15 October 2021

## **SECTION 4.55 (1A) - MODIFICATION OF DA20/0685: SITE 2B OAKDALE SOUTH ESTATE (MOD 2)**

This Section 4.55(1A) modification application has been prepared by Urbis on behalf of Goodman Property Services (Aust) Pty Ltd (the **Applicant**).

Figure 2 – Comparison of Approved and Proposed Office Locations

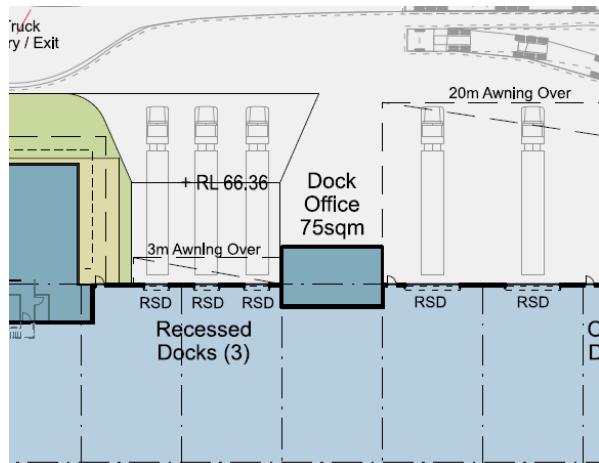
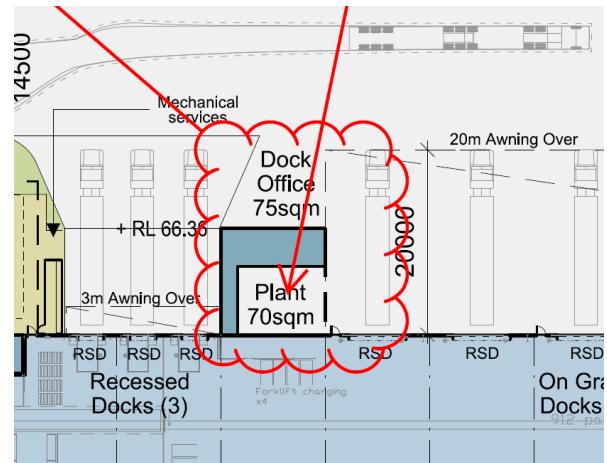
- Installation of mechanical units on the roof of the warehouse and commensurate increase in overall building height by 1m (from 15m to 16m).
- Change of use of a portion of the tenancy to light industry as an ancillary use to the primary purpose of the site for warehouse and distribution, to meet tenant requirements.
- Relocation of 2B-1 dock office, with a minor increase in approved GFA of 25m<sup>2</sup> (from 27,595m<sup>2</sup> to 27,620m<sup>2</sup>).
- Minor amendments to the approved fit out plans to meet tenant requirements.

The proposed modifications are shown in red clouding on the Architectural Plans prepared by SBA Architects and extracted below.

Figure 3 – Comparison of Approved and Proposed South Elevation Plans

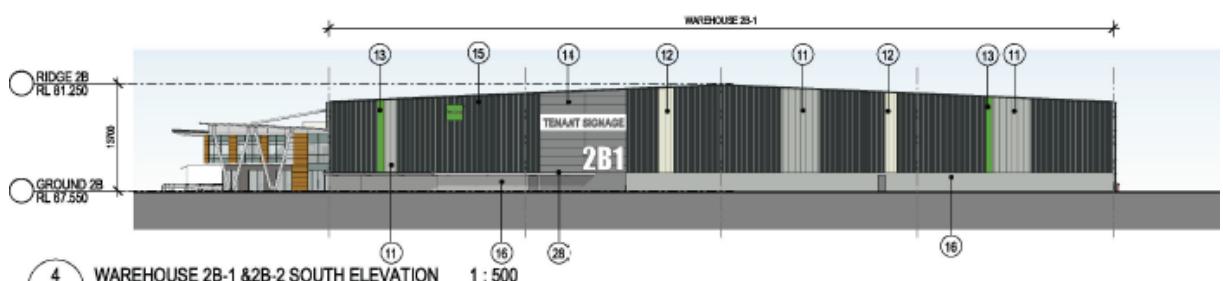
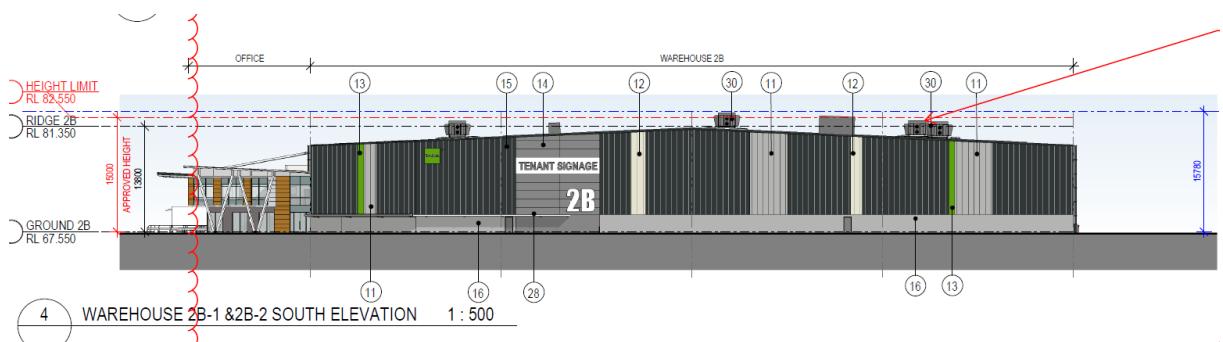
- Installation of mechanical units on the roof of the warehouse and commensurate increase in overall building height by 1m (from 15m to 16m).
- Change of use of a portion of the tenancy to light industry as an ancillary use to the primary purpose of the site for warehouse and distribution, to meet tenant requirements.
- Relocation of 2B-1 dock office (with associated minor increased in GFA of 25m<sup>2</sup>).
- Minor amendments to the approved fit out plans to meet tenant requirements.

- The proposed 1m increase in building height relates to the addition of mechanical units to the rooftop and does not generate additional bulk or gross floor area of the approved building. The proposed mechanical units are required to meet tenant demand and are consistent with the industrial setting of the Oakdale Industrial Estate. The increase in overall maximum height allowance for the Precinct 2B is being considered concurrently by DPIE as part of SSD-6917 MOD 16.

Figure 4 – Comparison of Approved and Proposed Roof Plans

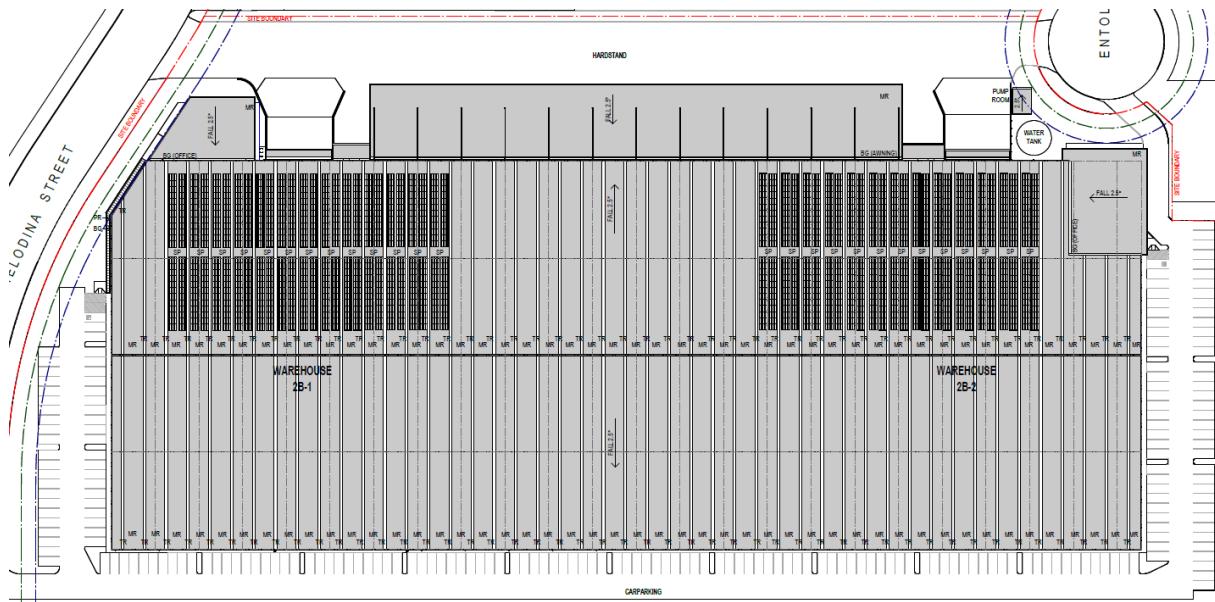
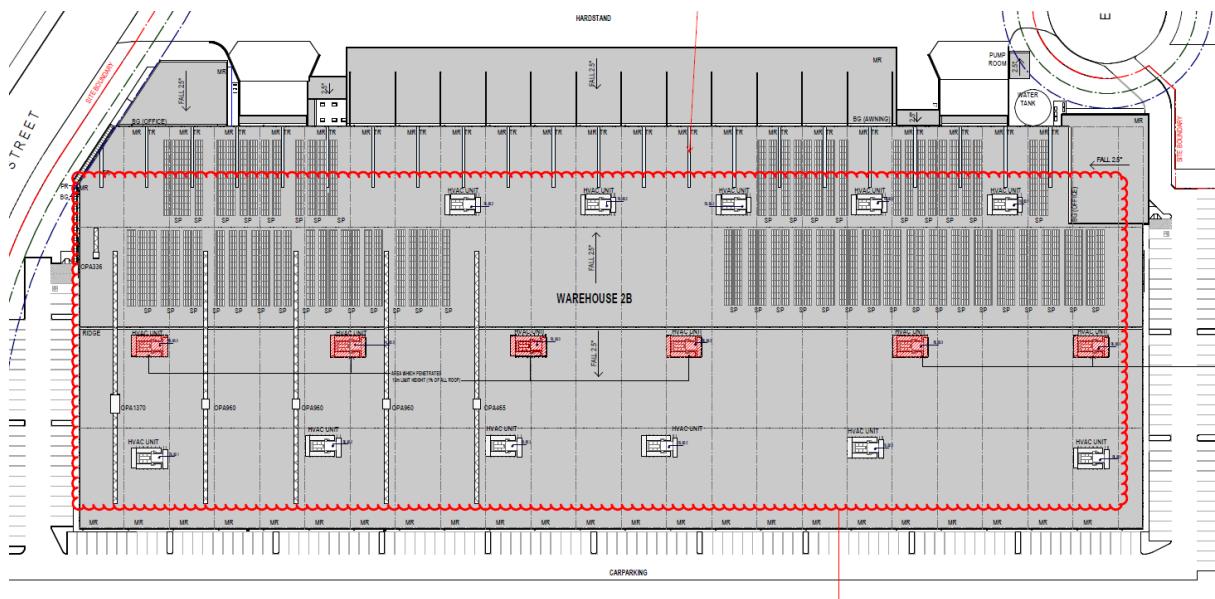
The proposed design changes the location of the external mechanical plant, detailing specific units and locations for each of the offices and dock offices. Additionally, temperature control units are proposed on the warehouse roof, and freezer plant on the 2B-1 dock office roof. It is noted that no other operational details of Site 2B are proposed to be modified.

Figure 5 – North Elevation Plan

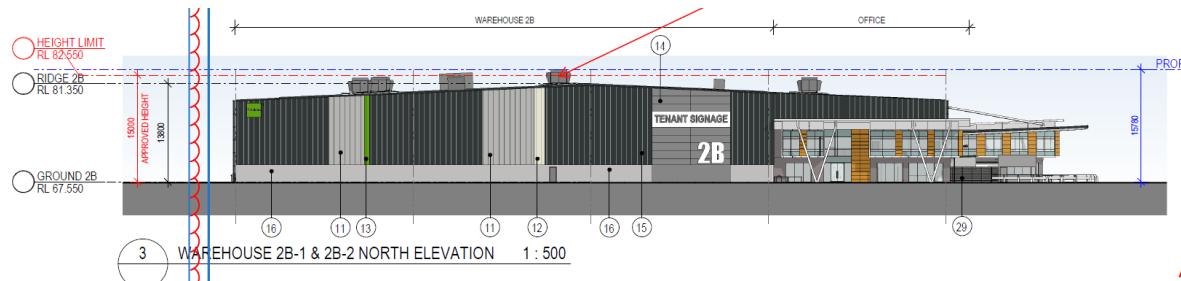
The proposed 1m increase in building height relates to the addition of mechanical units to the rooftop and does not relate to additional bulk or gross floor area of the approved building. The proposed mechanical units are required to meet tenant demand and are consistent with the industrial setting of the Oakdale Industrial Estate. The site is not immediately adjacent to residential land and as such would be viewed from a distance within the context of the broader industrial character of the OSE. Therefore, the location of mechanical units to the rooftop is anticipated to have a negligible visual impact to the locality.
